# Response to EA Submissions

## Report to Department of Planning

Project Application 07\_0160

## **Update to Submissions Report**

**Figure 20 Model W2: Piezometric Draw down at Year 38 with Kh x 100**

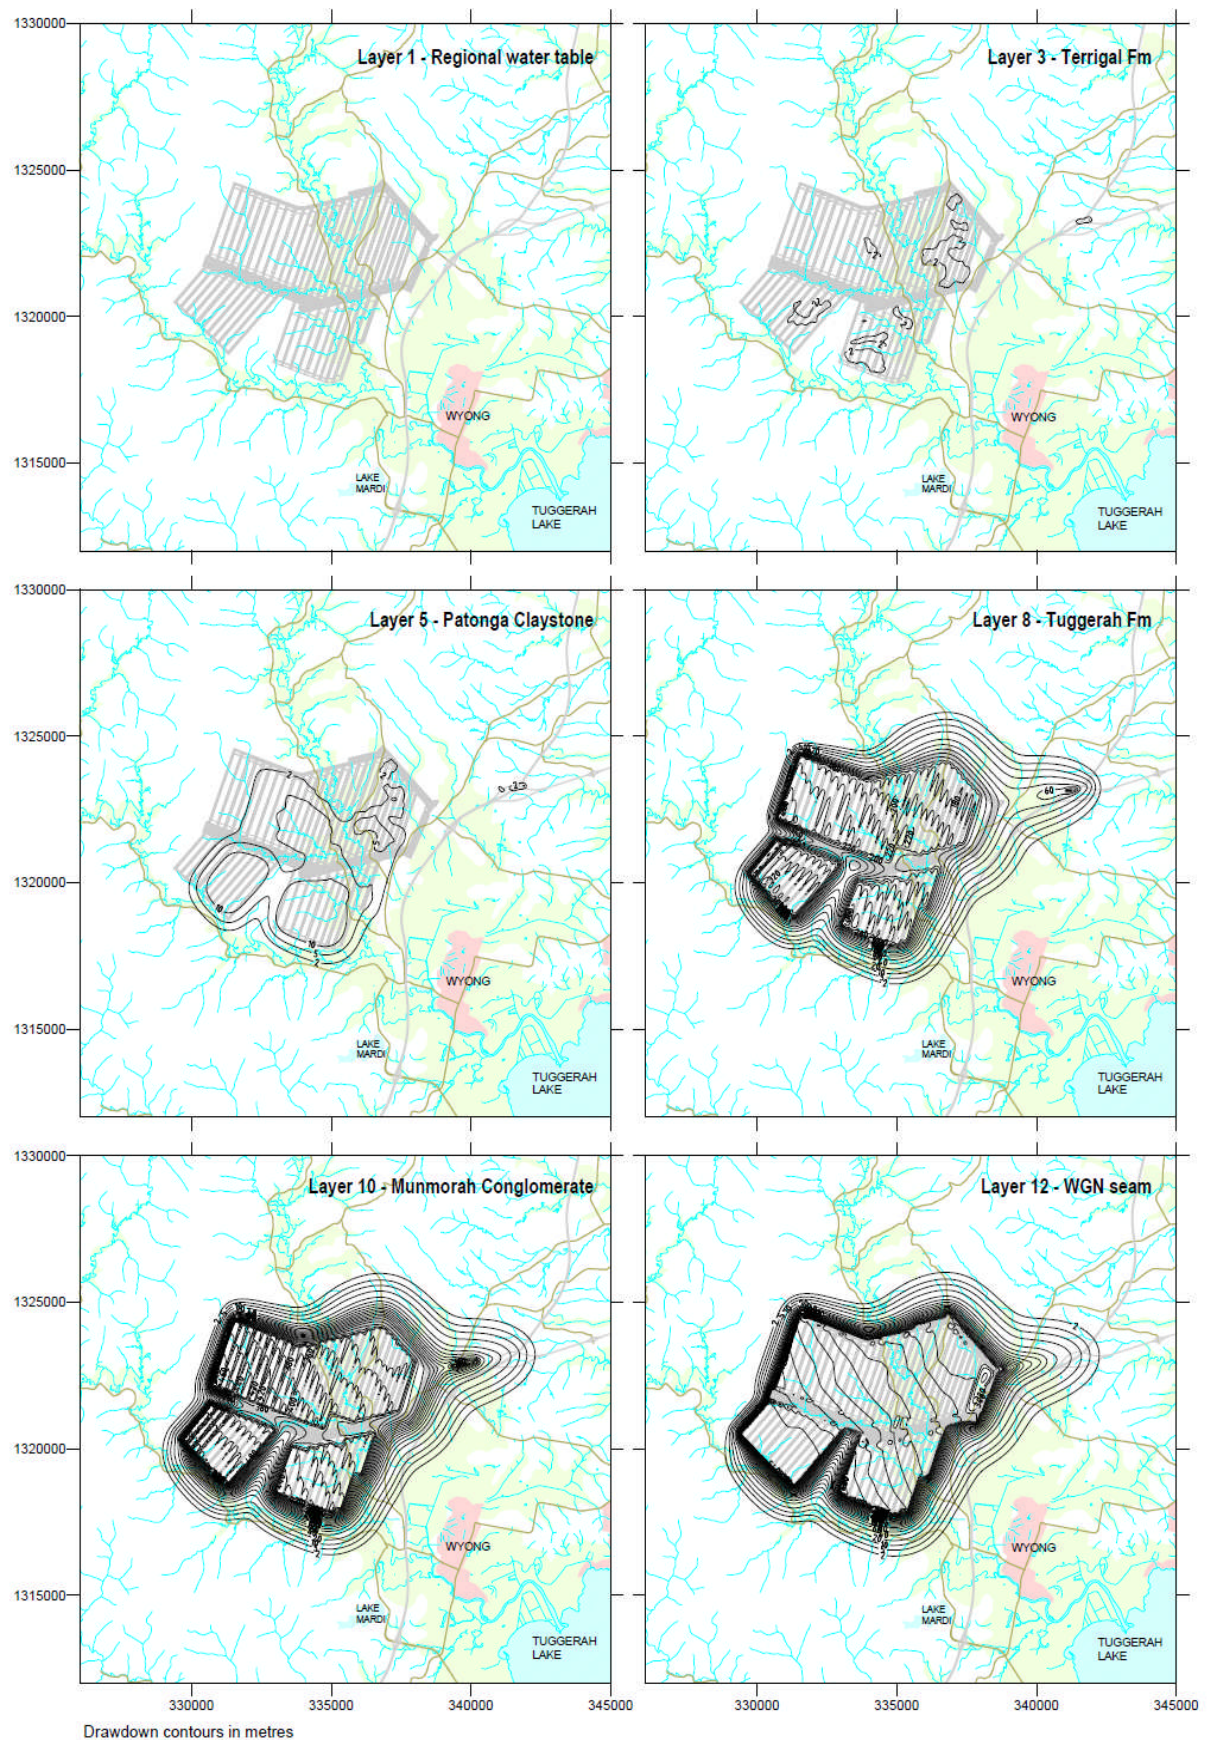
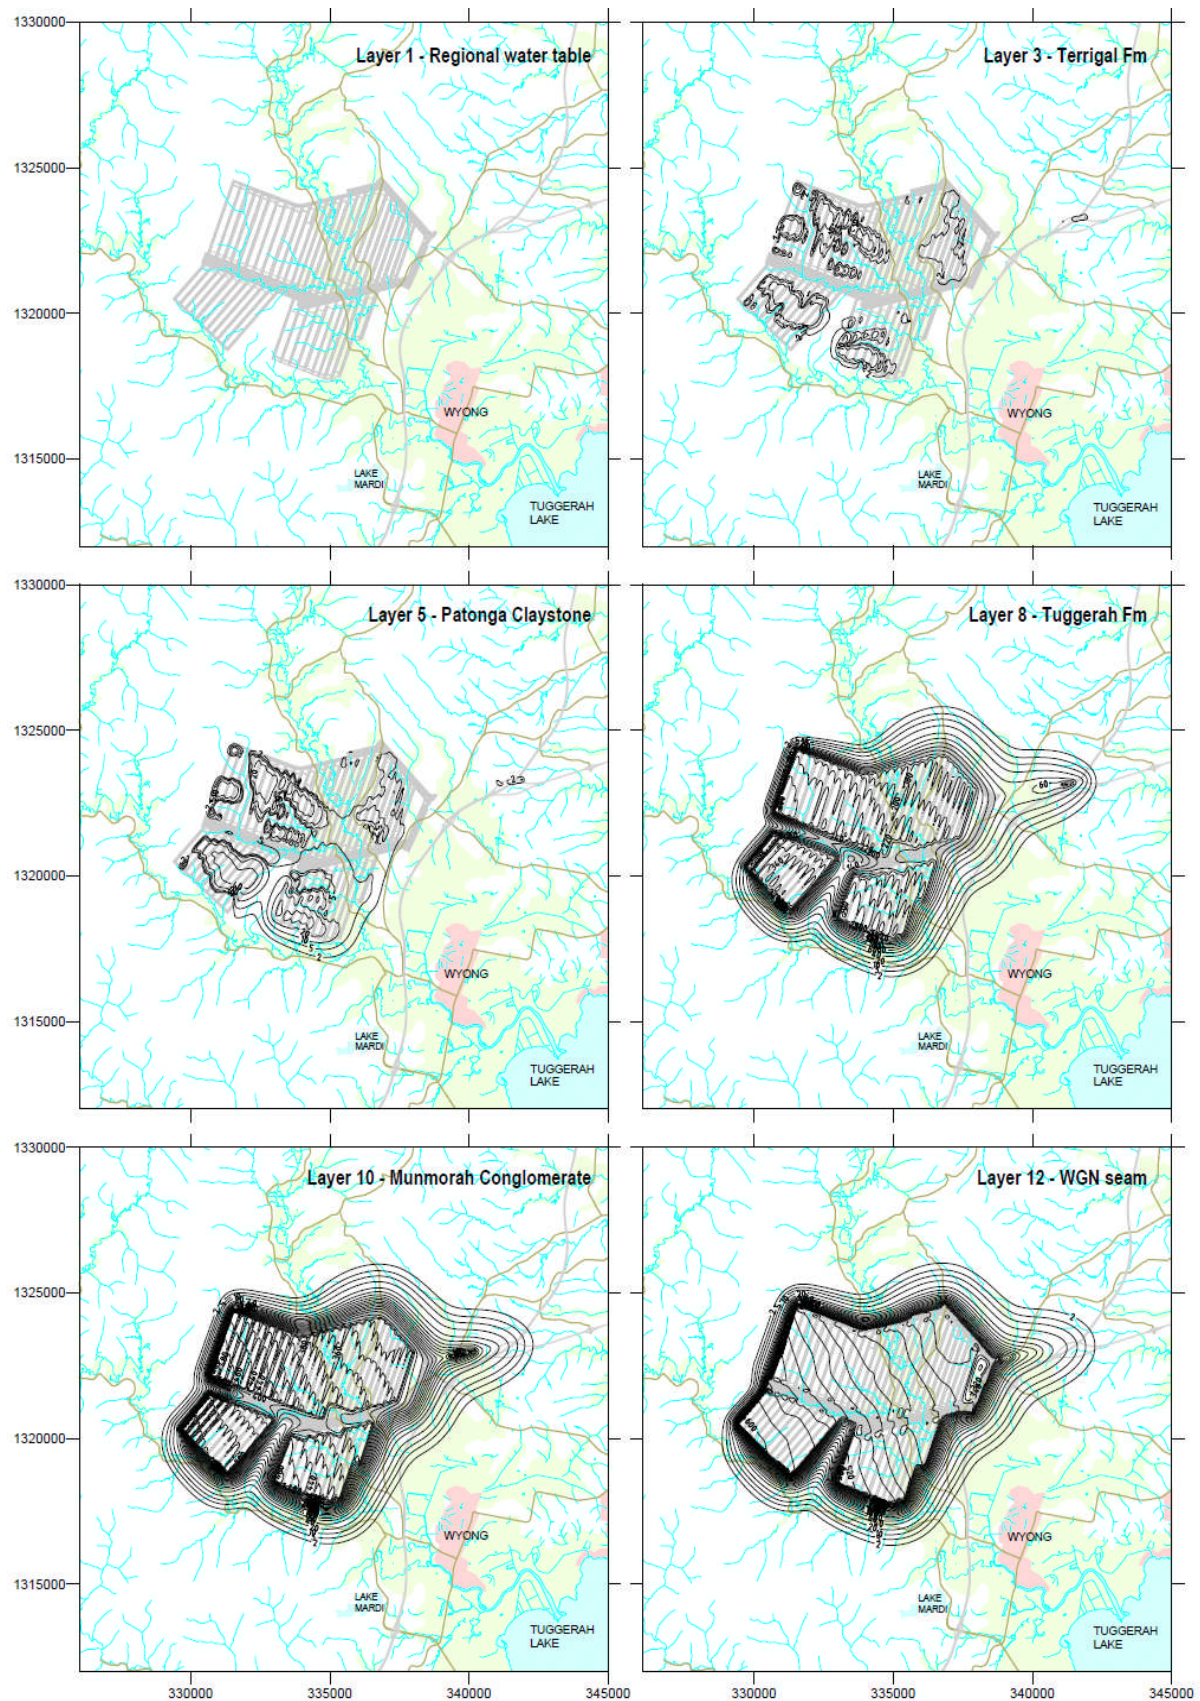
While not included in the reported groundwater modelling (MER 2009), MER has also undertaken additional model simulations that include up to 100 fold increase in horizontal permeability (Kh) over extracted longwall panels in the constrained zone layers 2 to 7 in order to approximate potential changes induced by bed separations. MER note that this is a conservative approach since close inspection of SCT predicted horizontal bed separations (Figure 17 above) shows that such zones are commonly discontinuous (no enhancement).

Drawdown plots at the end of mining for the base case (MER, 2009) and the case of increased horizontal permeability, are provided as Figure 19 and Figure 20. Comparison of responses indicates negligible difference in the alluvial lands but there is an increased loss of pore pressure (drawdown) in deeper layers of the constrained zone. Calculated mine seepage rates and stream baseflows remain essentially unchanged.

**Figure 21 Histograms for Core Permeability Tests - EA (left) and updated (right) distributions**

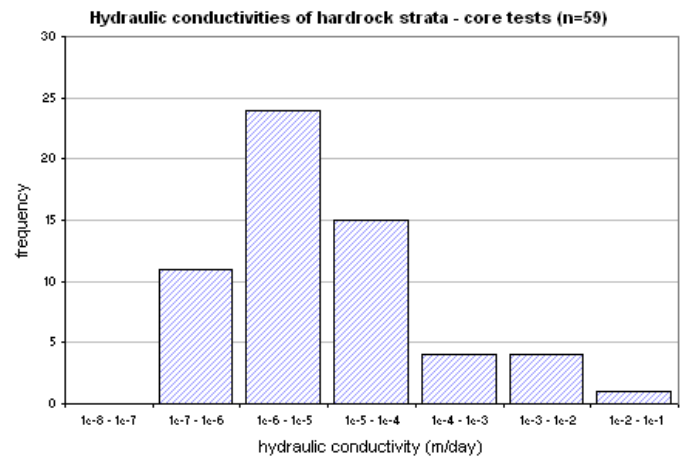
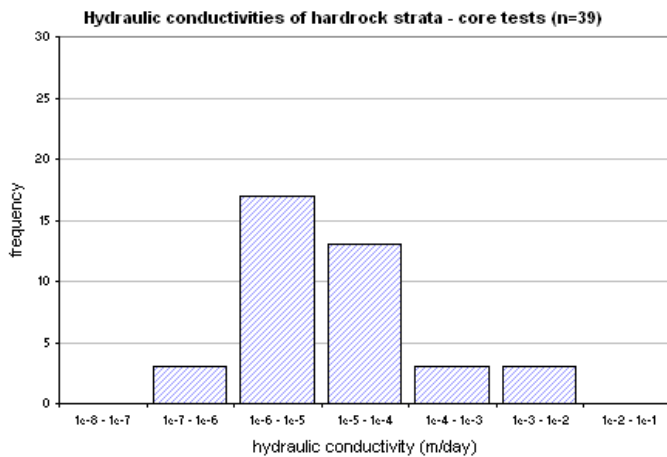
Additional core testing has been undertaken for samples obtained from boreholes located beneath the alluvial lands associated with Jilliby Jilliby Creek. Depths of sampling were generally within the first 100 m and included the Patonga Claystone and the underlying Tuggerah Formation. These results have been combined with the EA reported results and are summarised on the following histograms in Figure 21.

Fine grained siltstones fall in the range  $1\text{E-}7$  to  $1\text{E-}6$  m/day; claystones would be expected to exhibit a lower range.

**Figure 22** Slide from COAL AGC Presentation 2000 used in Northern Geoscience Report

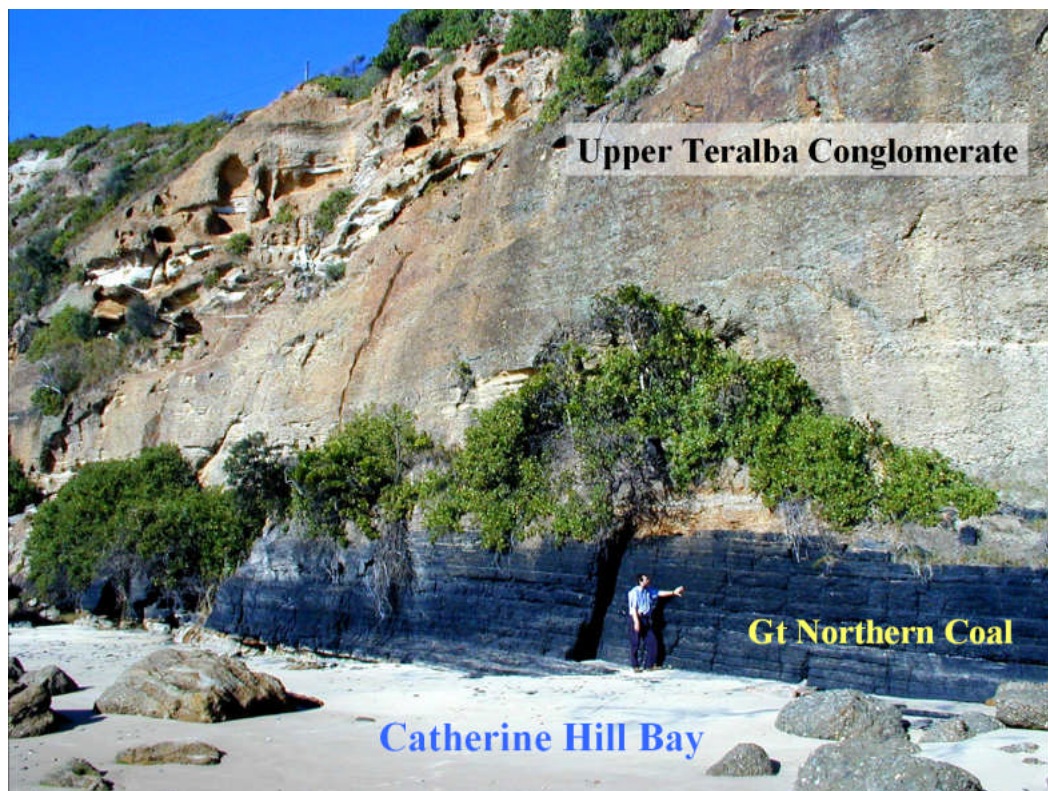
The Northern Geoscience report has a number of mentions of “faults”, “fracture zones” and “crush zones”. It also mentions “geophysical evidence” and “geological mapping”. Most of these statements are very generalized in nature and non-specific. On page 23 a very specific mention is made that “a major 45° fault separates the sandstone rock units” above the coal seam in a photograph. This photograph is actually a COAL photograph of the Great Northern Seam outcrop at Catherine Hill Bay which was used in a paper presented at the Australian Geological Convention in 2000 (Lindsay and Herbert 2000). The report by Jones erroneously refers to incorrect stratigraphic units and incorrectly claims the existence of a fault which does not exist.

Unfortunately such generalisations and obvious errors throw doubt on validity of other claims within the report.

**Figure 23 Northern Geosciences' alleged fault at the Jilliby Creek – Little Jilliby Creek confluence**

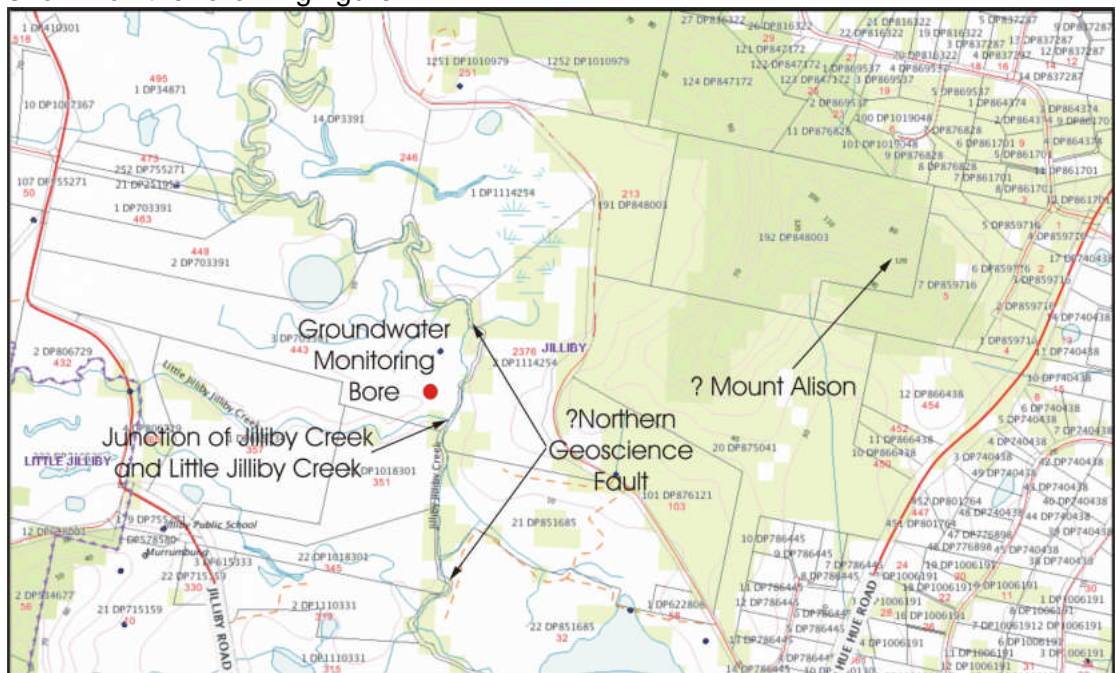
Northern Geoscience simply states that this fault exists but offers no evidence pointing to its existence.

No official reference can be found to Mount Alison within the Wyong LGA. However, an old topographic map shows a trig station tagged Alison approximately 1.5 km north of the Hue Hue Road and Dickson Road intersection. From the description quoted above the claimed fault is located along a north-south stretch of Jilliby Jilliby Creek to the north and south of its junction with Little Jilliby Creek, as shown on the following figure.

During early 2010 the Wallarah 2 Coal Project installed a ground water monitoring bore approximately 100m west of the stream bed. Bedrock was intersected at a depth of 20 metres. While aerial photographic interpretation of lineaments can indicate the location of faults, such interpretations are only valid in areas of little to no alluvial cover. It is difficult to believe that a fault can be interpreted to exist at this location when the bedrock is covered by such a depth of alluvial fill.
